**Natural Resources Defense Council  
The Bay Institute  
American Rivers  
Audubon California  
California Sportfishing Protection Alliance  
Friends of the River**

October 27, 2014

**RE:    Comments on the Upper San Joaquin River Basin Storage Investigation Draft  
          Environmental Impact Statement**

Figure 1 Reduction in spills under Alternative 4

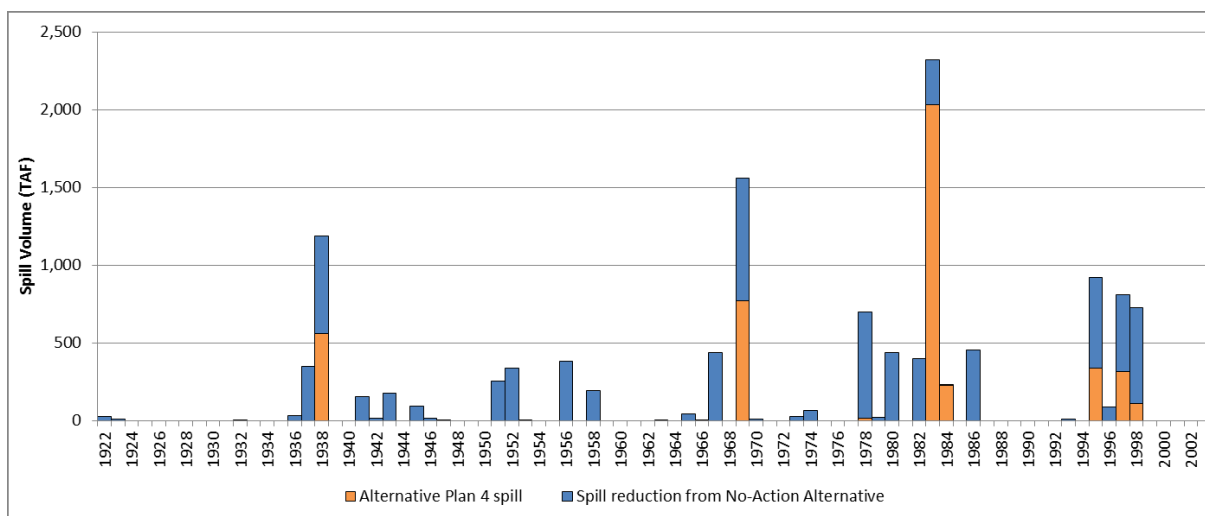
**Other Social and Ecological Impacts: Moreover,** the focus on a single species fails to account for the potential impact of Temperance Flat reservoir on species upstream and downstream of the proposed reservoir. The Investigation clearly identifies these losses in habitat and impacts on other wildlife and fisheries, but does nothing to quantify these costs in the cost-benefit analysis:
